STAFF RECOMMENDATION

1507 Fatherland Street

February 21, 2018

Application: New construction - addition

PHOTOGRAPHS

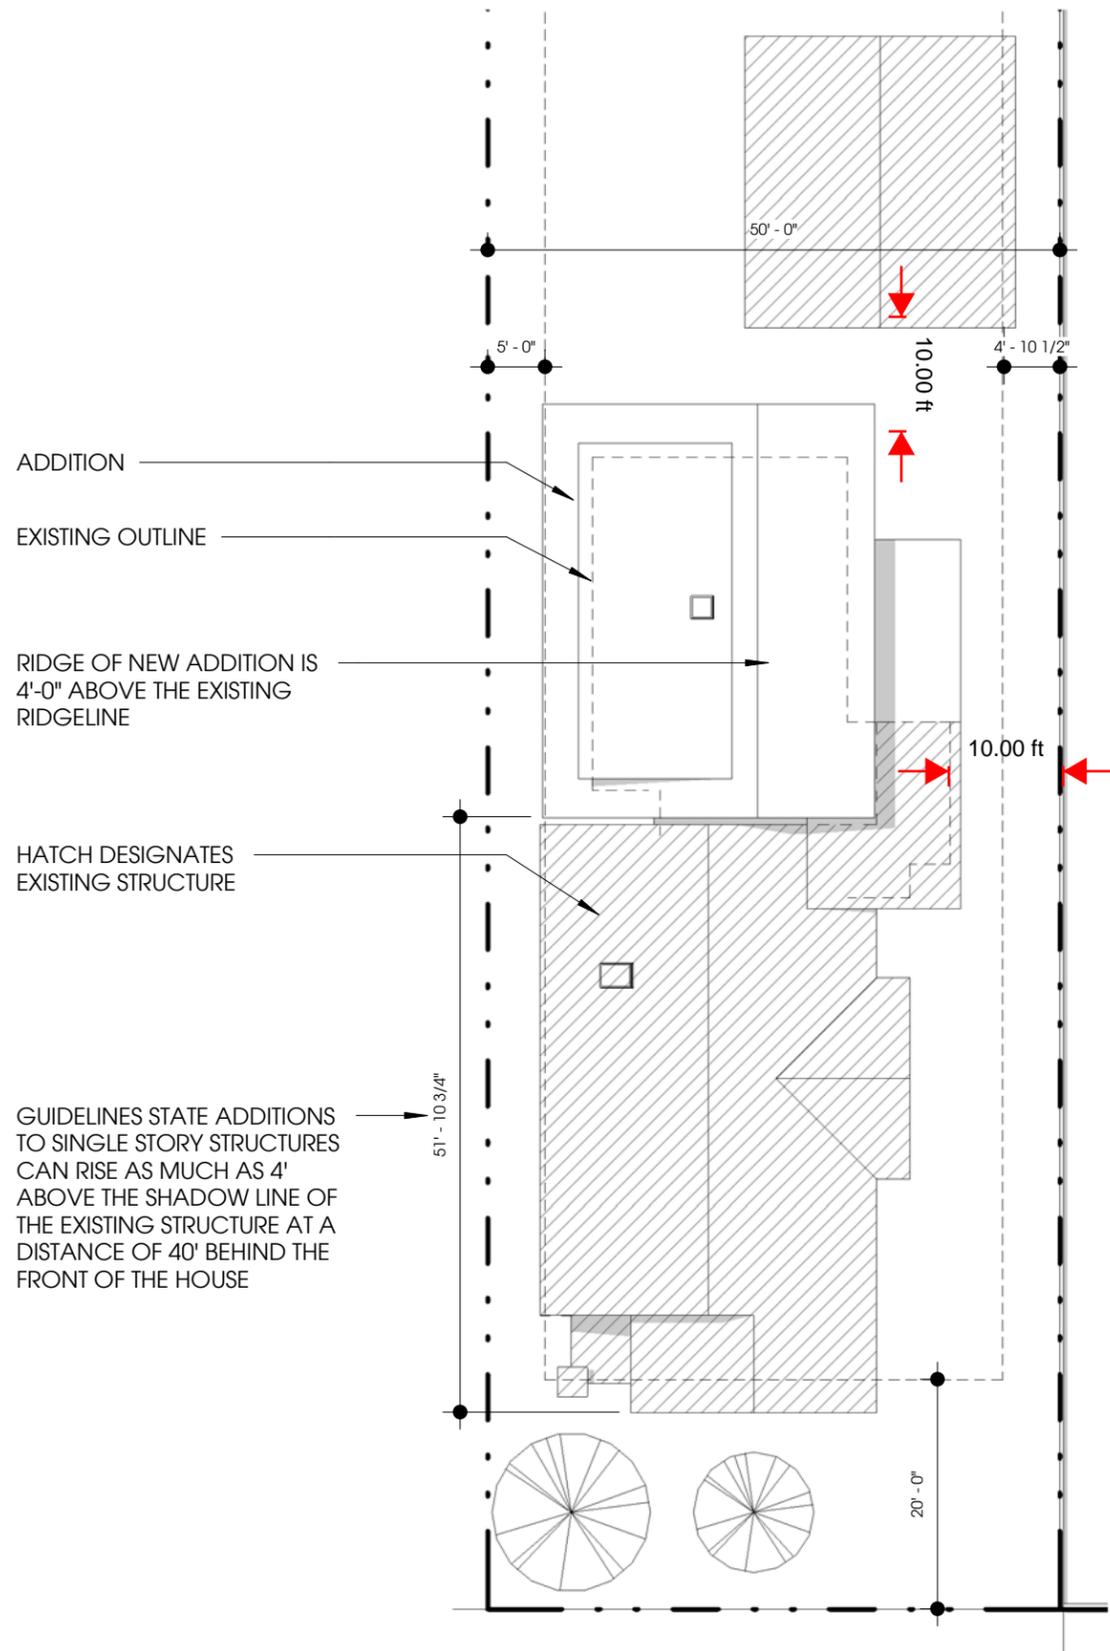
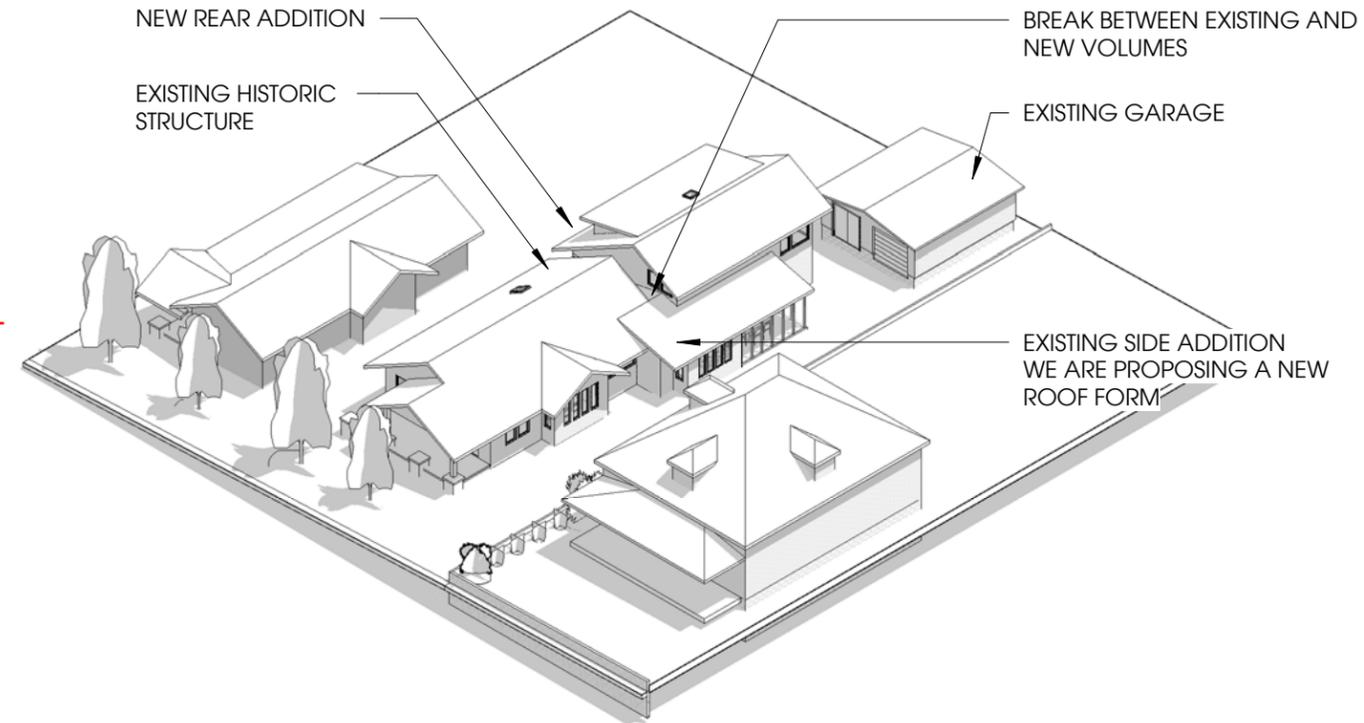
Background: The house at 1507 Fatherland Street is a one story front gabled Craftsman style bungalow. The house has a front-gabled porch and has been enlarged with a one-story addition on the rear and right side.

H2.1

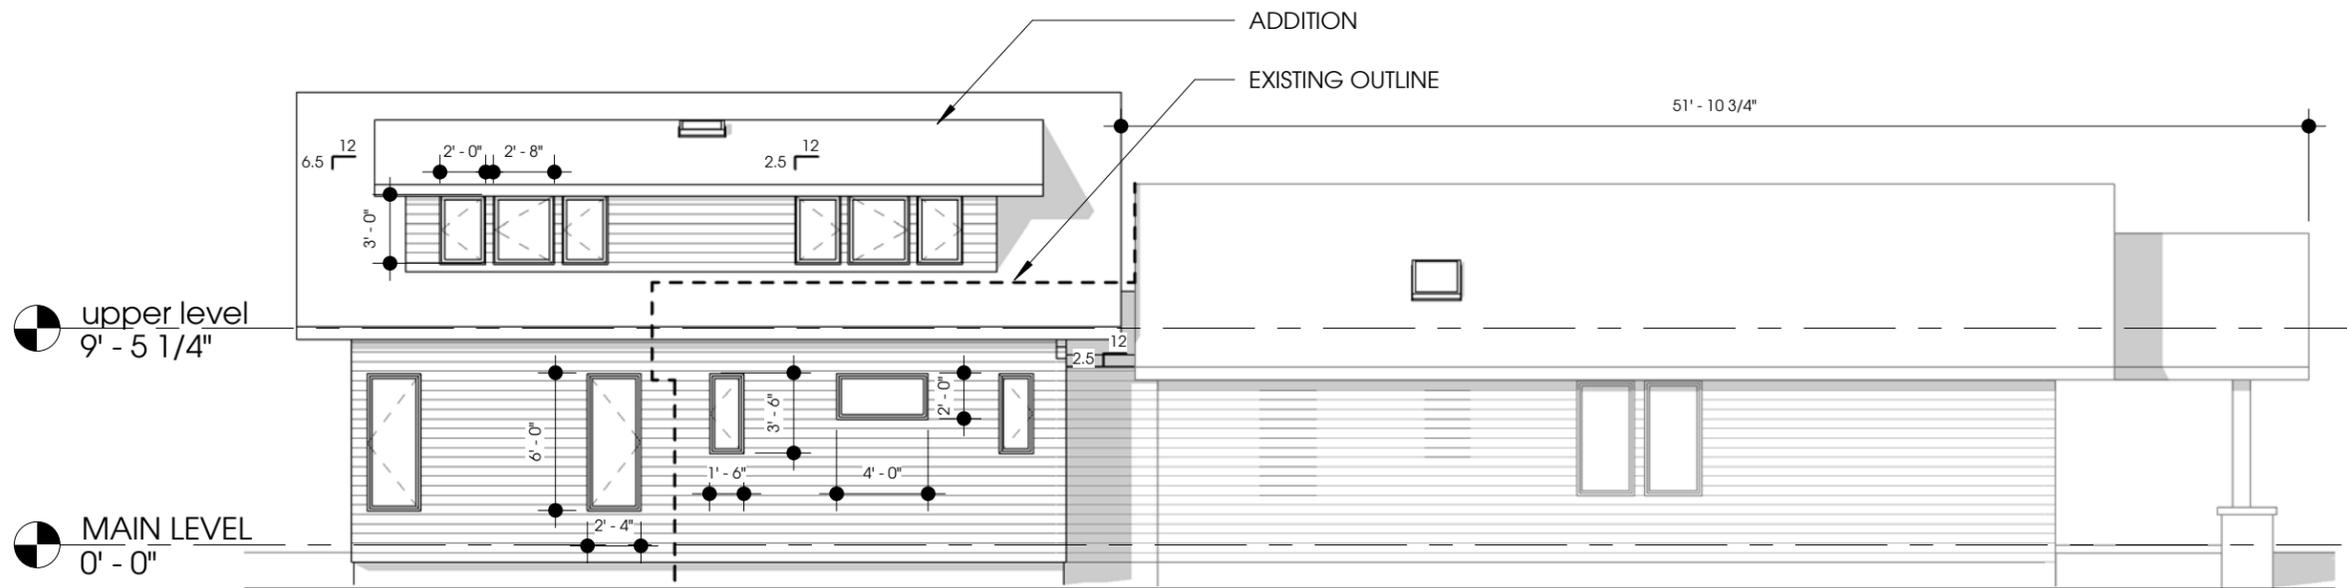
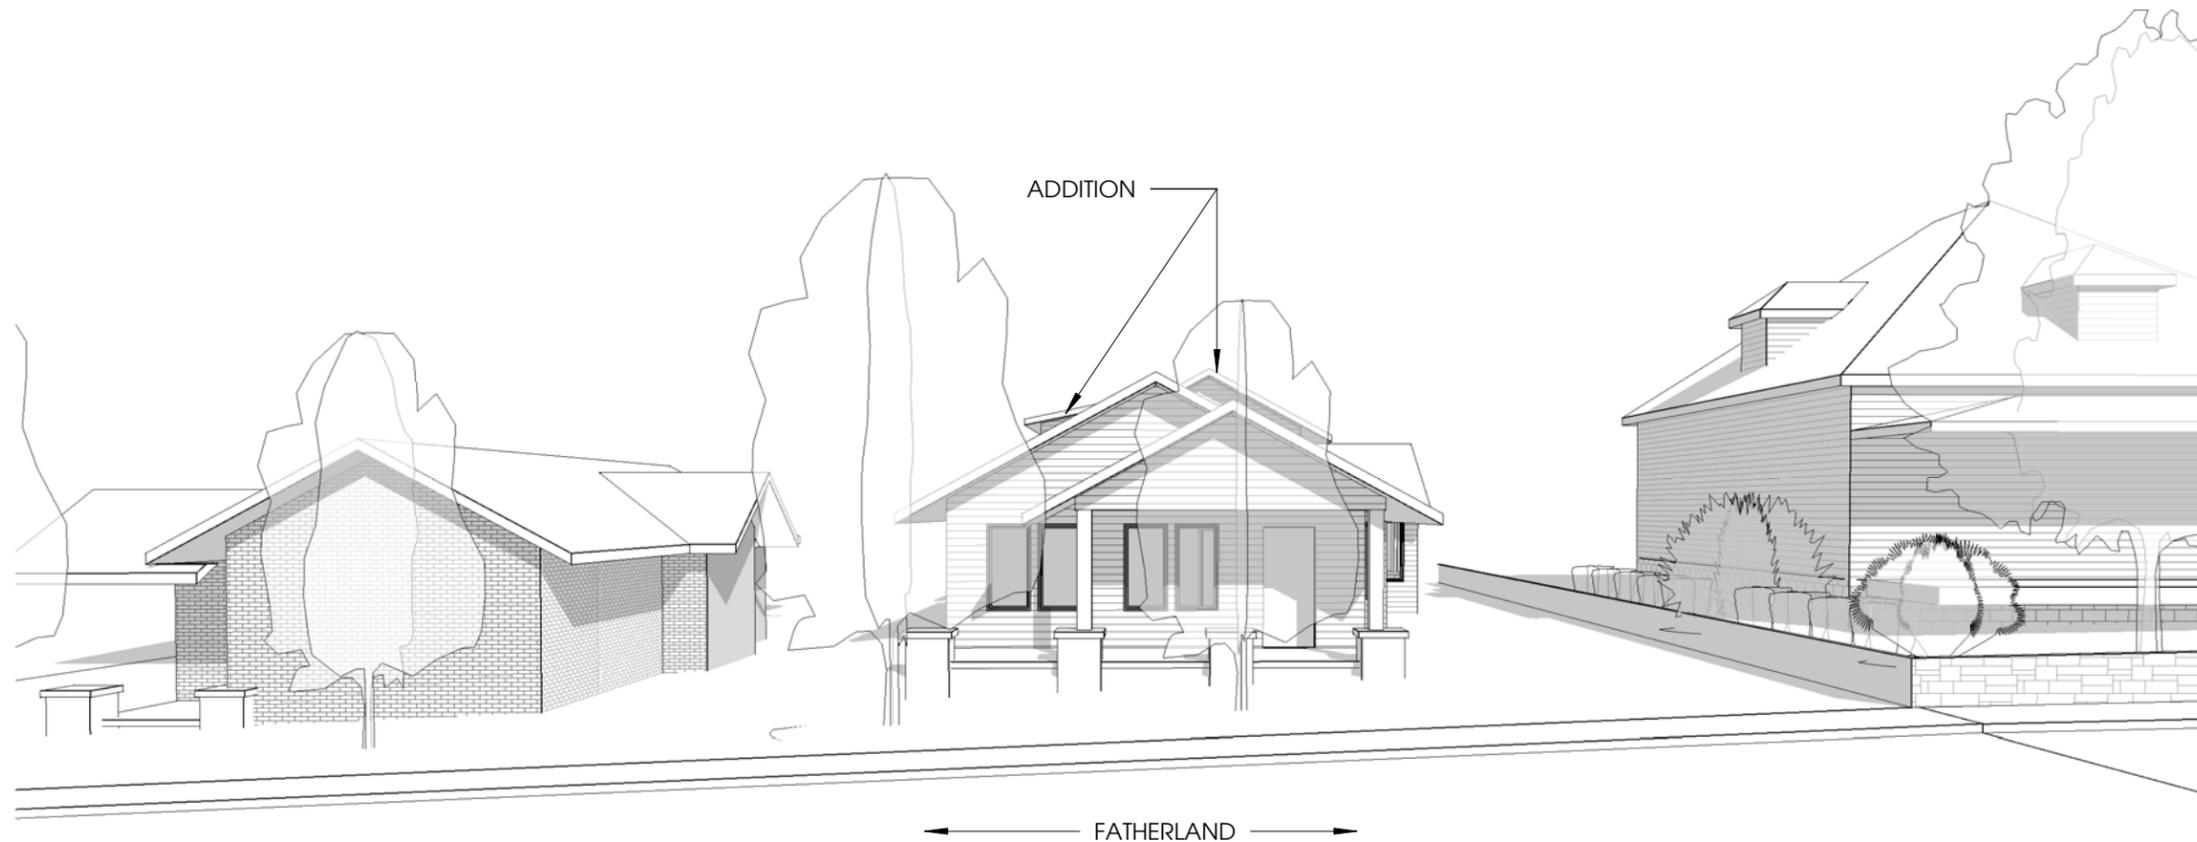
Location & Removability: The proposed addition will have two stories with a roof height peaking at four feet (4') higher than the ridge of the existing roof. The addition will match the width of the primary mass of the original structure, with a four foot (4') deep inset section on the left side to differentiate the new construction from the existing on the first story. On the right side, the addition will tie into the existing side addition so the impact will be on a section of the building that has already been altered. The second story will begin behind the four foot (4') deep inset "hyphen" of the addition, approximately fifty-two feet (52) back from the front edge of the house. Connecting the addition to the historic house in this way allows the roof and eaves of the existing building to be left intact.

Design: The material and window pattern will be compatible with the historic house and the addition will match the width of the existing building and have a similar roof form. Overall, the form of the addition will be similar to that of the historic house, however because the addition

will be taller than the one story historic house with a highly visible second story, Staff finds the project does not meet sections II.B.10.a and II.B.10.b of the design guidelines.

Height & Scale: The addition will have a front-gabled roof, matching the form and pitch of the roof on the historic house. The new ridge will be higher and offset to the right of the original roof, resulting in eaves and roof planes of the new roof one foot (1'-9") higher than the original on the left side, four feet (4') taller than the central peak, and approximately six feet, six inches (6'-6") higher on the right roof plane. The design guidelines allow for additions taller than the historic building only when necessary. In this case there are no atypical lot conditions such as an unusual size or shape of the lot or severe change in grade that precludes a compatibly scaled addition. In addition, when single story additions are not feasible it may be appropriate for additions to extend up to four feet (4') beyond the "shadowline" of the house provided that the visible roof is hipped or has clipped gables to reduce its visibility. Staff finds that the proposed addition does not meet this guideline because: one, a compatibly scaled addition may be possible; two, the proposed additions extends more than six feet (6') beyond the shadowline of the historic house on the right side; three, the roof of the addition is not hipped or clipped as the guidelines stipulate; and four, there is no condition such as atypical lot dimensions or shape or grade that requires a two-story addition at this location.

There will also be a shed-roofed dormer on the left side of the roof to facilitate more upperstory space. Although the dormer, which runs nearly the entire length of the roof, is larger than most historic dormers, it would be stepped two feet (2') back from the wall below to help break up the perceived scale. The addition will match the width of the existing house on the first story, with the left wall aligned with the original left wall and the right side aligned with the wall of the earlier addition. The upperstory walls will be aligned with the side of the original building on the right side, and the left side will be stepped in two feet (2') as is generally typical for a dormer.

Staff finds the scale of the proposed two story addition to the one story historic house is not subordinate to the house, and that the project does not meet section II.B.10.a of the design guidelines.

Recommendation: Staff recommends disapproval of the proposed two story addition to the historic house at 1507 Fatherland Street, finding that the scale of the addition is not compatible and that it does not meet the design guidelines for the Lockeland Springs-East End Neighborhood Conservation Zoning Overlay.
